| <b>Device</b>       | <b>C505A-4RM,<br/>C505CA-2RM/4RM/LM,<br/>C505CA-4RC</b> |
| <b>Marking/Step</b> | <b>Step ES-CA, CA</b>                                   |

This Errata Sheet describes the deviations from the current user documentation.

### **CAN.3: Description in User's Manual regarding the reception of remote frames and the data length code (DLC) field is incorrect**

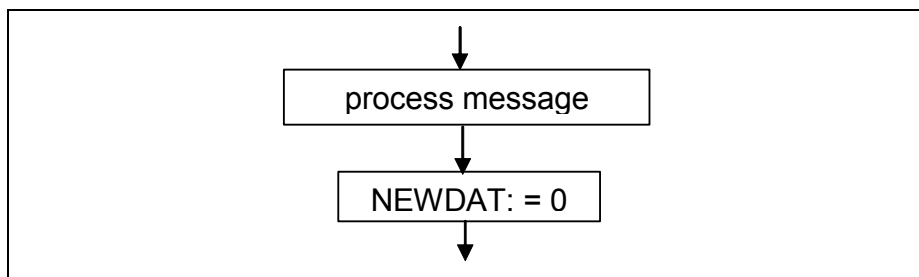
It is inaccurately described in the User's Manual on page 6-94 under 'Arbitration Registers' that *'When the CAN controller stores a remote frame, only the data length code is stored into the corresponding message object'*. The correct should be that the DLC field remains unchanged in the receiving message object, and that the CPU has the responsibility to define the DLC of the answering data frame.

This correction will be updated to the future versions of the User's Manuals.
